An Bord Pleanála Oral Hearing

Irish Water

Greater Dublin Drainage

General Response to Water Quality Model

Fig 1(b): GDD model: Flood Tide

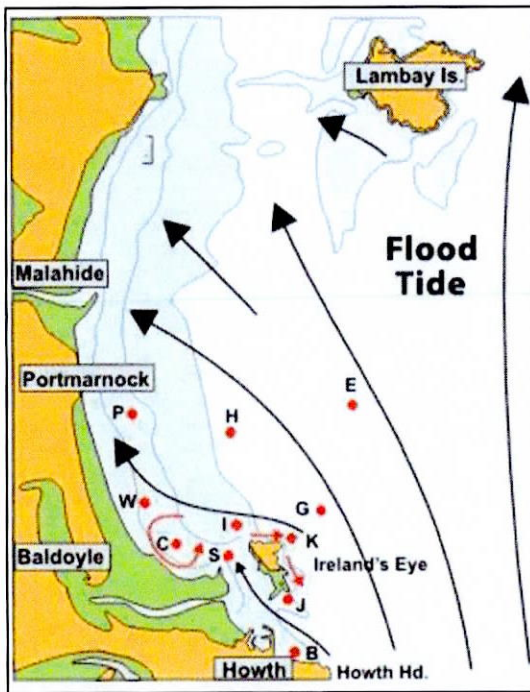
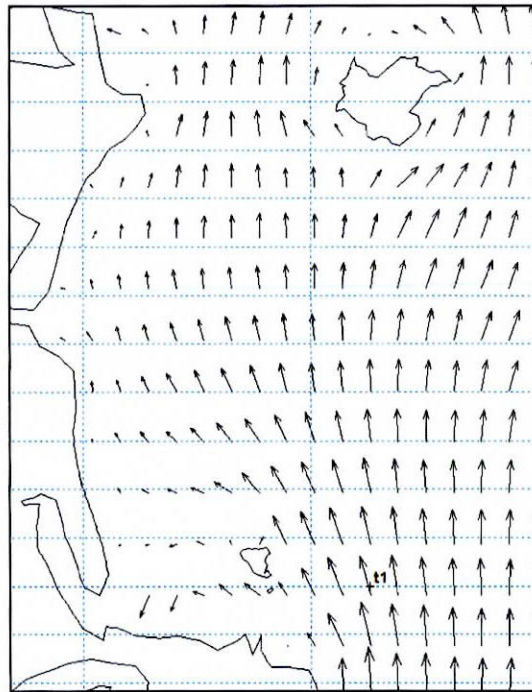
6. Comparing Fig 1(a) with Fig 1(b) (from the Response to An Bord Pleanála of Jan 2019) for flood tide circulation patterns between Howth and Lambay Island it can be seen that; (i) both maps show the flooding tide to the north and east of Ireland's Eye stronger than the flooding tide between Ireland's Eye and the Baldoyle Estuary as well as showing the same direction for the tidal currents; (ii) to the north of Ireland's Eye both maps show the flooding tide on a northwesterly heading with a notable westerly component towards Portmarnock; (iii) both maps show the flooding tide diverging to the east and west around Lambay Island;

Fig 2(b): GDD model: Ebb Tide

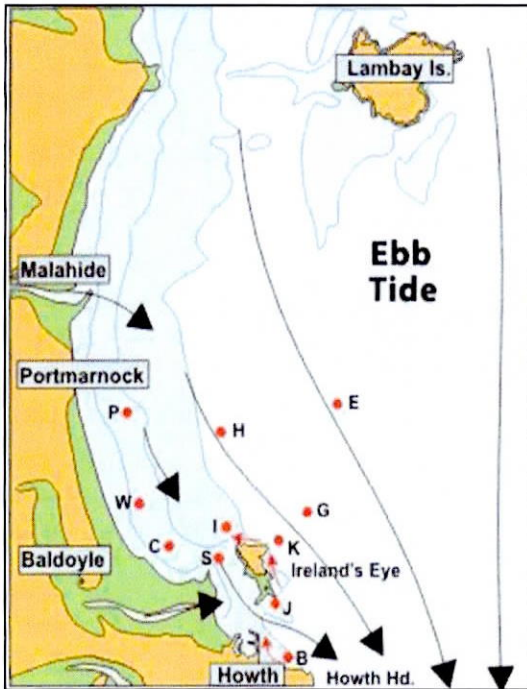
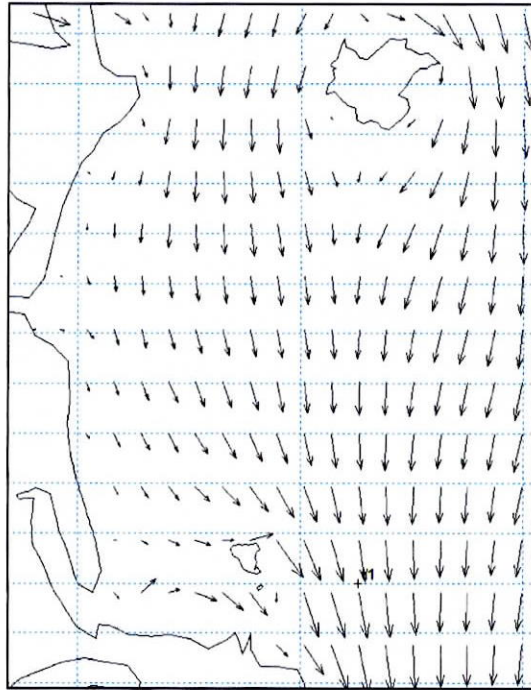
7. Comparing Fig 2(a) with Fig 2(b) for ebb tide circulation patterns between Howth and Lambay Island it can be seen that; (i) both maps show the ebbing tide between Ireland's Eye and Lambay Island on a south-southeasterly heading, with the 'offshore' ebbing tide to the east of Lambay Island on a southerly heading; (ii) both maps show the nearshore ebbing tide on a south-southeasterly heading meeting then turning due east off Baldoyle Estuary.

Fig 3(b): GDD model: Flood

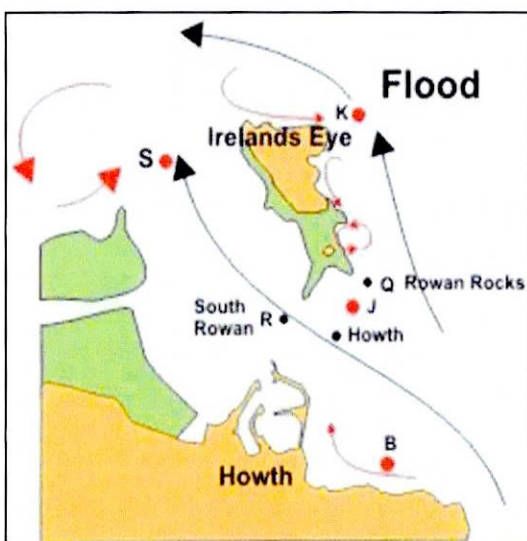
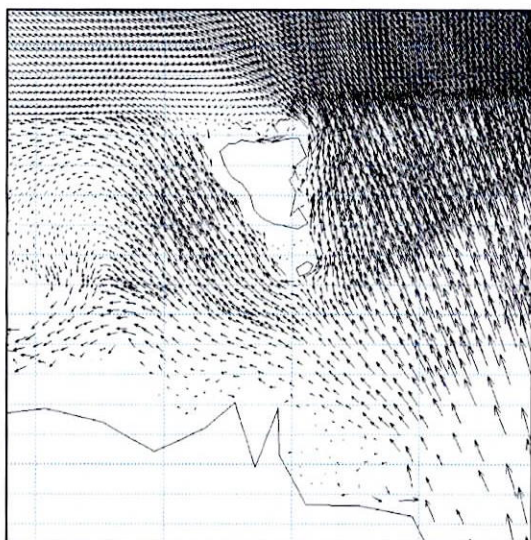
8. At higher resolution, comparing Fig 3(a) with Fig 3(b) (from the Response to An Bord Pleanála of Jan 2019) for flood tide circulation patterns around Ireland's Eye it can be seen that; (i) both maps show the flooding tide between Ireland's Eye and Howth on a northwesterly heading, with a much weaker tidal current immediately to the east of Howth Harbour; (ii) both maps show the magnitude of the flooding current to the east and west of Ireland's Eye to be almost equal; (iii) both maps show an anti-clockwise re-circulation / gyre structure to the west of Ireland's Eye and to the north of Baldoye Estuary; (iv) both maps show an anti-clockwise re-circulation / gyre structure immediately north of Ireland's Eye at a much lesser magnitude than that of the predominant northwesterly flooding tide.

Fig 4(b): GDD model: Ebb Tide

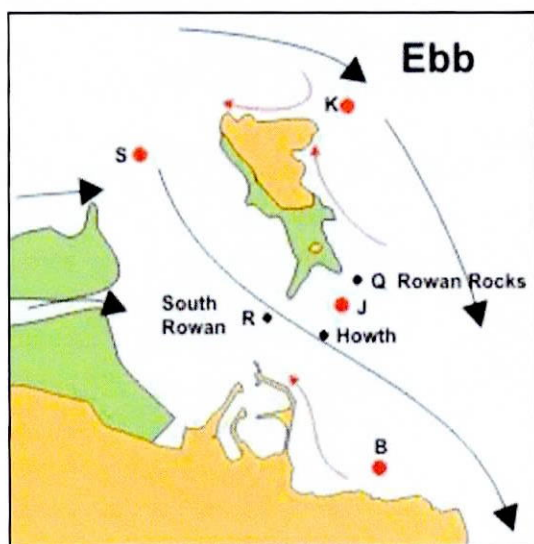
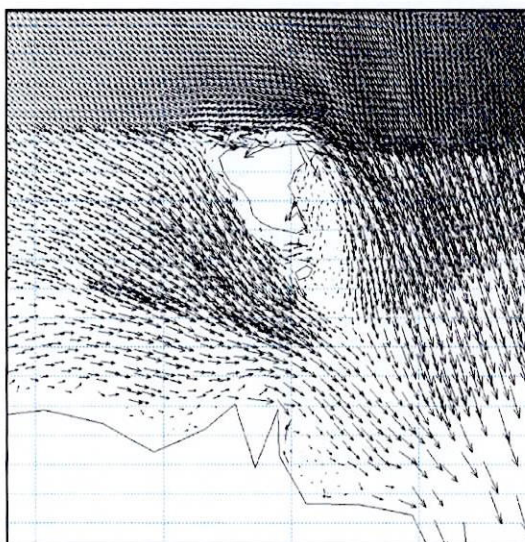
9. Comparing Fig 4(a) with Fig 4(b) for ebb tide circulation patterns around Ireland's Eye it can be seen that; (i) both maps show the ebbing tide between Ireland's Eye and Howth on a southeasterly heading, with a counter current immediately to the east of Howth Harbour heading in a northerly direction; (ii) both maps show the magnitude of the ebbing current to the north, east and west of Ireland's Eye to be almost equal; (iii) both maps show a weak counter current immediately to the east of Ireland's Eye; (iv) both maps show a weak clockwise re-circulation / gyre structure immediately north of Ireland's Eye.

Figure A1.15 – Dye Release, Spring 1

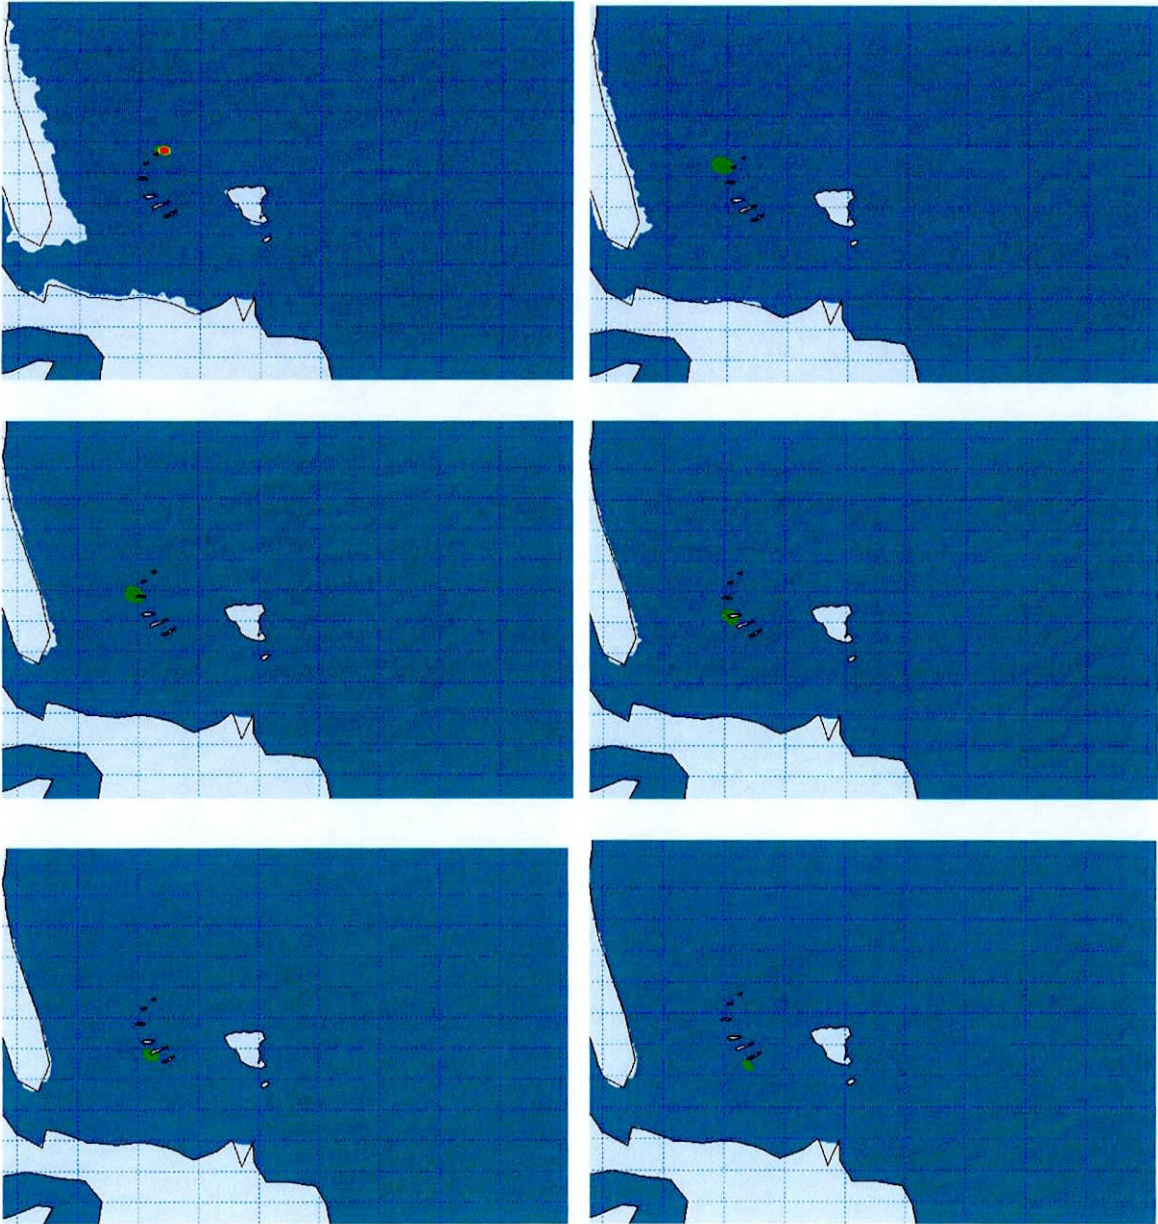
10. Moving on to the accuracy of the model in representing observed dispersion patterns in the region around Ireland's Eye; the solute transport (advection) model was calibrated against 2015 dye release surveys from locations around the area of interest, with 4 releases taking place on a spring tide and again on a neap (20th April 2015 and 9th June 2015 respectively). I submit a number of diagrams as presented in Appendix 8.1 of the EIAR.

11. These diagrams show that the model is capable of representing dispersion plumes in the area of interest around Ireland's Eye, both to the west and east of the island. The information published in the EIAR and Appendices shows that the model accurately represented the advection and dispersion of solute plumes throughout the area of interest.
12. Specifically responding to Cllr Healy request that modelling results have been inadequately presented, I submit the following assessment at Velvet Strand, Claremont, Bascadden Beach and Irelands Eye (closest location to outfall) for the proposed discharge subject to UV treatment.
